The Shaw Group Inc.™

March 13, 2007

**Subject: Addendum #1 – Final Remedial Action Report
Former Watchcase Factory Site
Site ID #152139**

TABLE 7C
SOIL VAPOR INTRUSION (SVI) ANALYTICAL DATA SUMMARY - VOLATILE ORGANIC COMPOUNDS

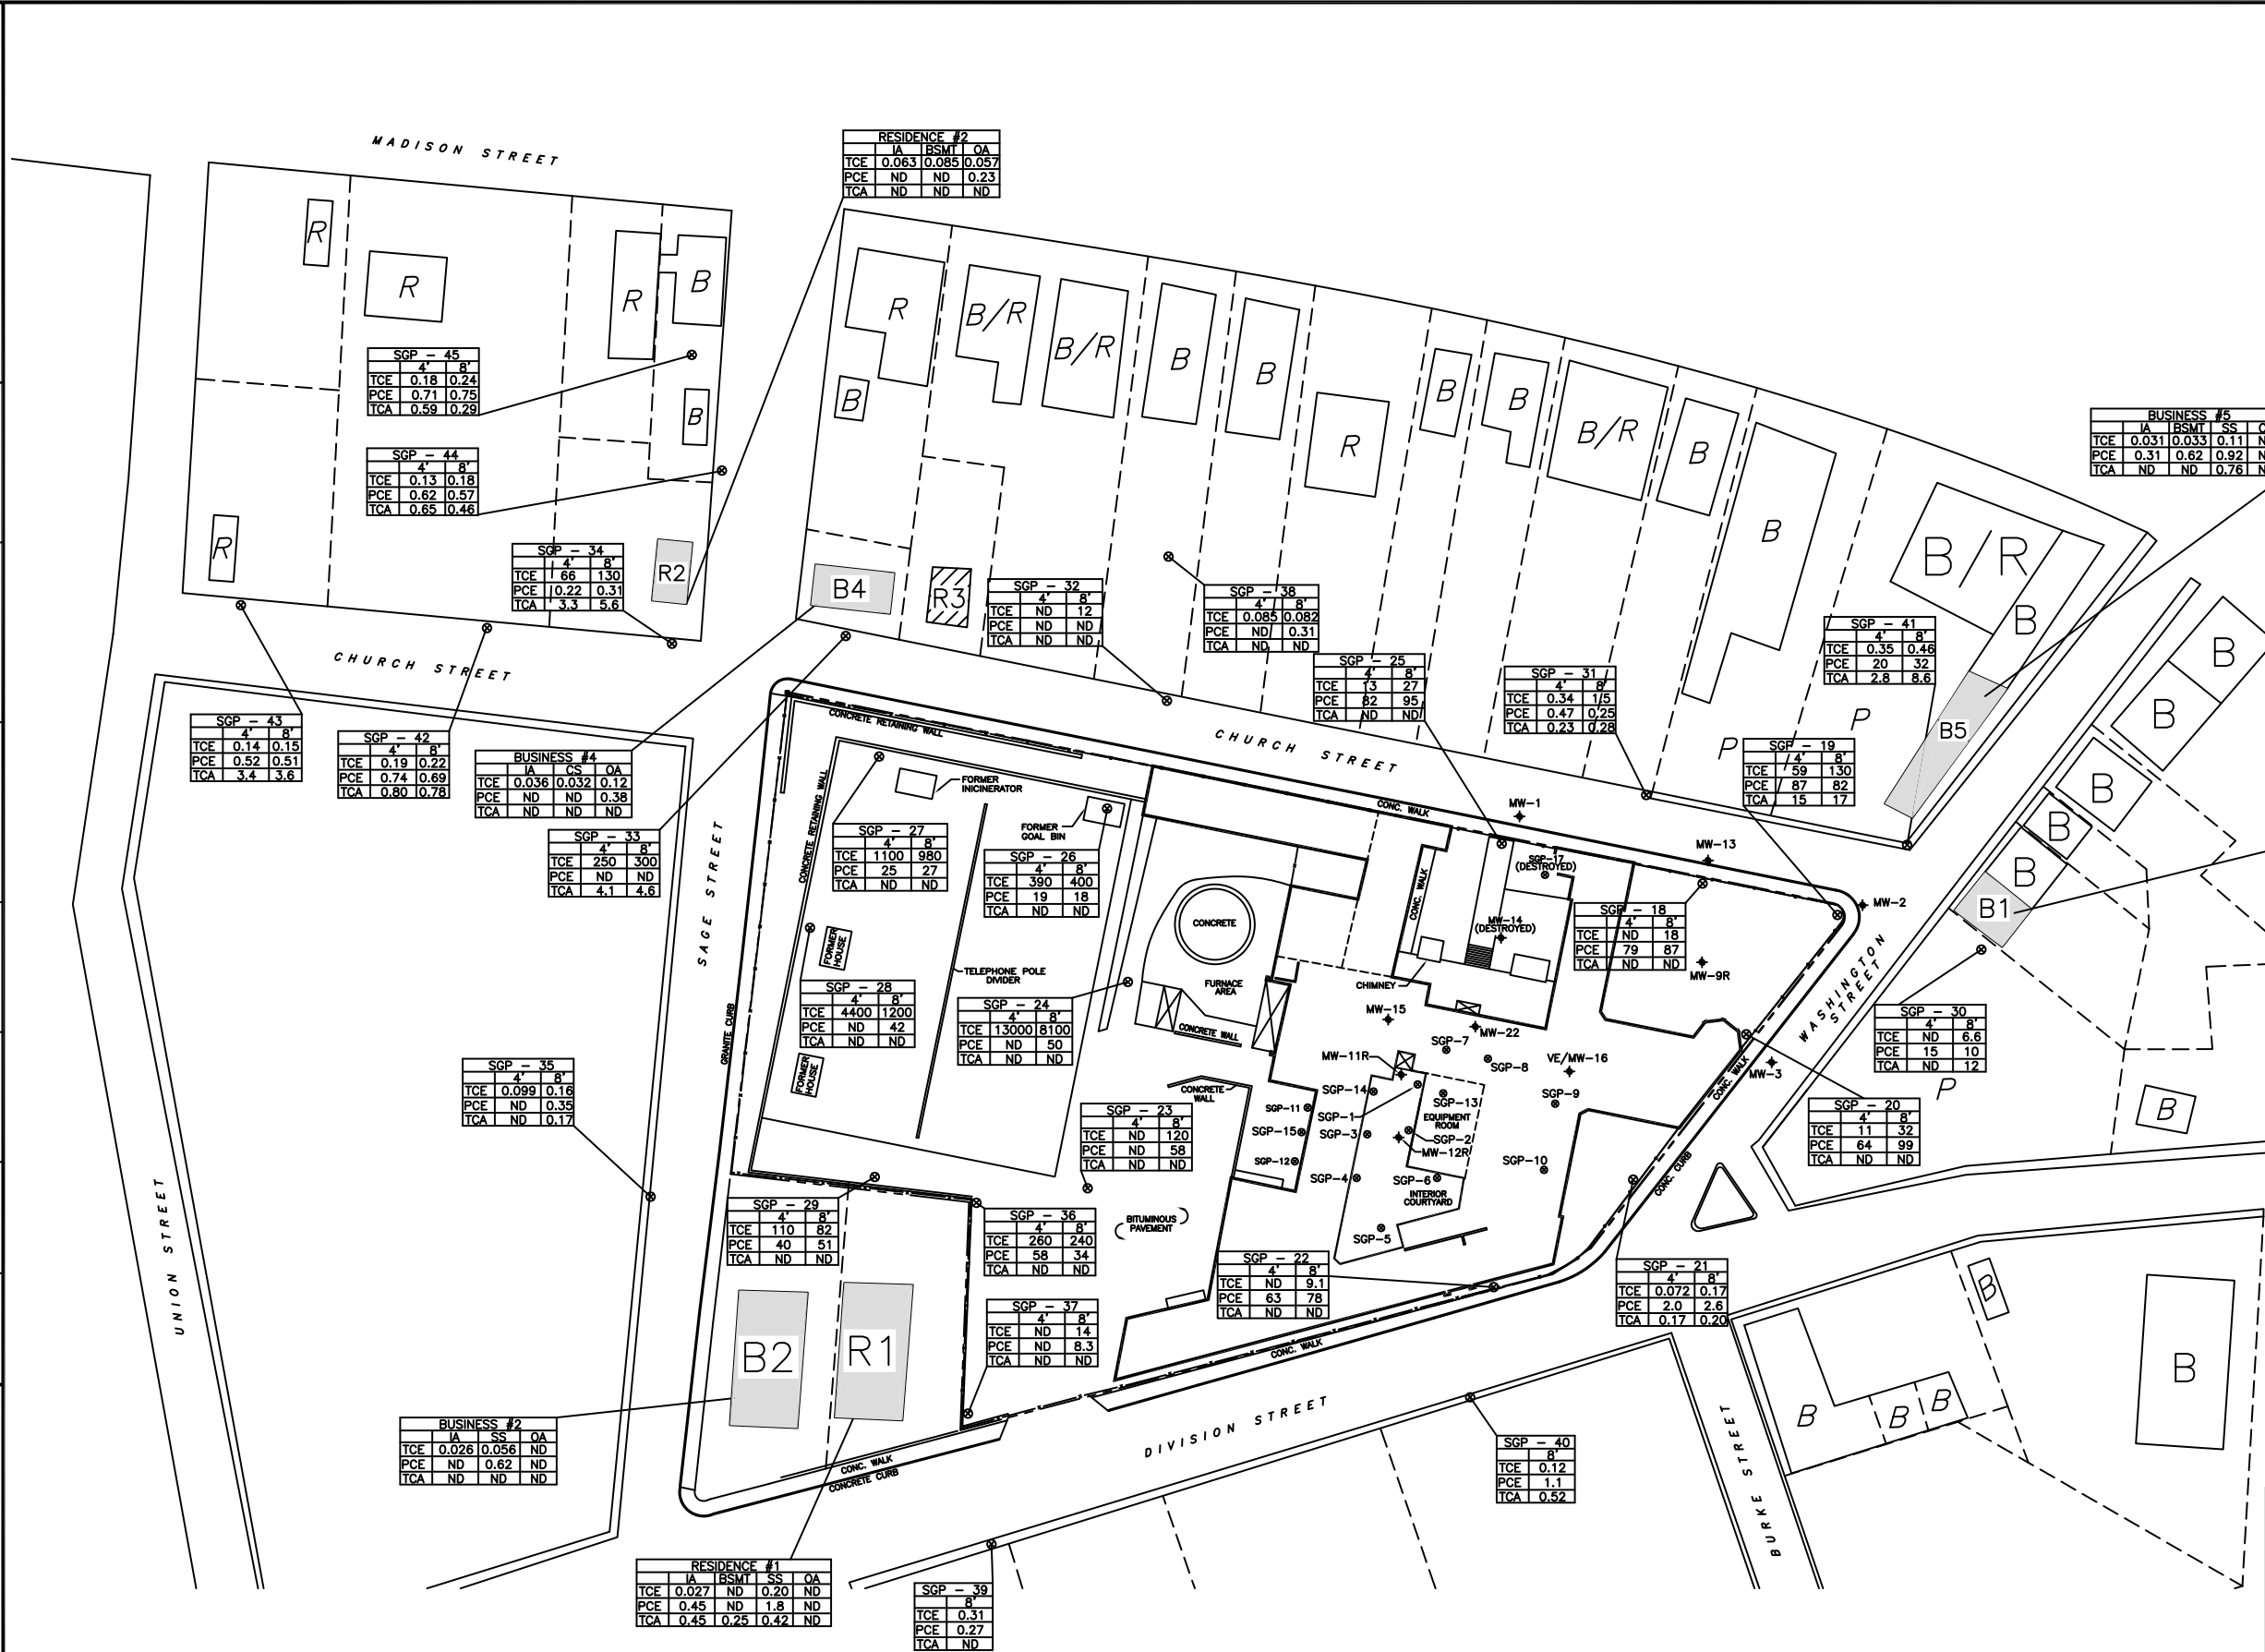
NYSDEC Comment #1 – Page 2, last paragraph: The statement, “Based on the results of the soil gas investigation and the SVIs, there are no issues relating to offsite vapor intrusion” is untrue as of today’s date and must be revised.

Revised Table 7C and Figure 4, which have been revised to include the results for Residence #2, are enclosed with this addendum.

SVI sampling activities for Residence #2 were completed on December 7 and 8, 2006. Results of the SVI sampling activities for Residence #2 are attached to this correspondence and are summarized below.
